UNITED STATES ENVIRONMENTAL PROTECTION AGENCY

September 6, 2013

Re: New Bedford Harbor-South Terminal Project

Figure 18. Explosive charge at Site 2: Peak pressure threshold of 75.6 psi for explosive charges between 30 and 150 lbs. Blue contours indicate water depth in feet.

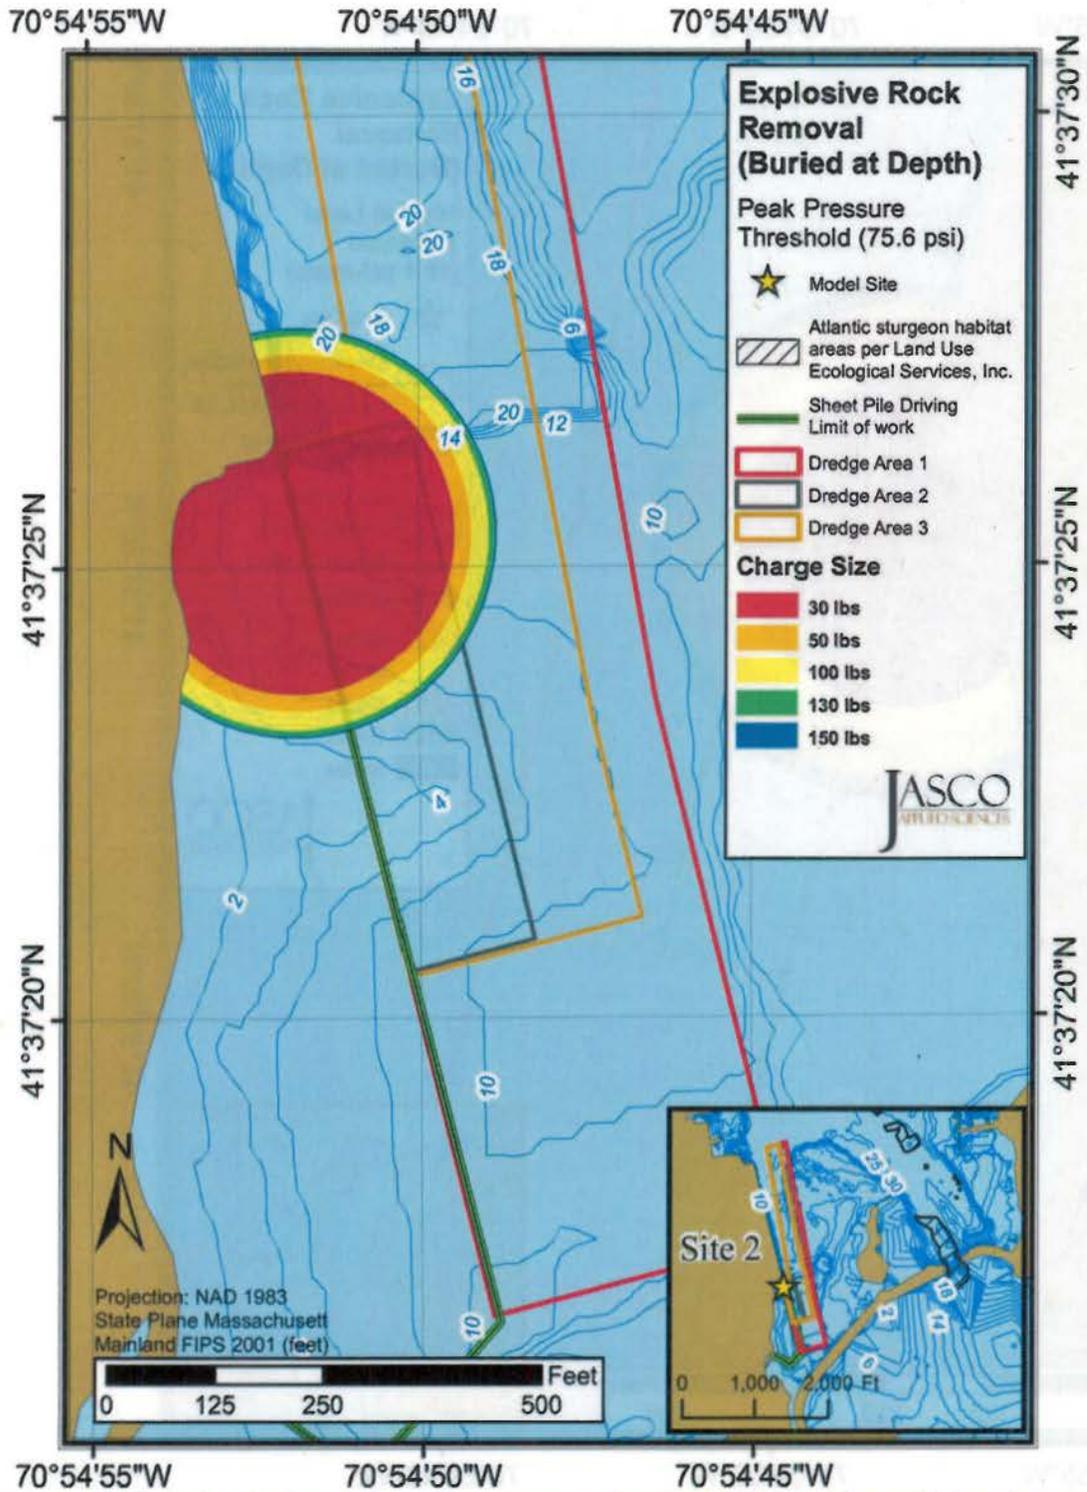
1. The difference in potential impact area between a 50 lb charge and the 150 lb charge is small (See Attached Figures 18 and 19 from revised JASCO report).
2. Potential acoustic impacts would be primarily limited to behavioral (avoidance) effects.
3. Potential acoustic impacts seem to be limited to an area surrounding the project site that represent less than approximately 1/3 of the cross-sectional area of the river. This leaves ample room for fish passage.
4. Bubble curtains can be employed as an effective means of minimizing the potential area of impact.
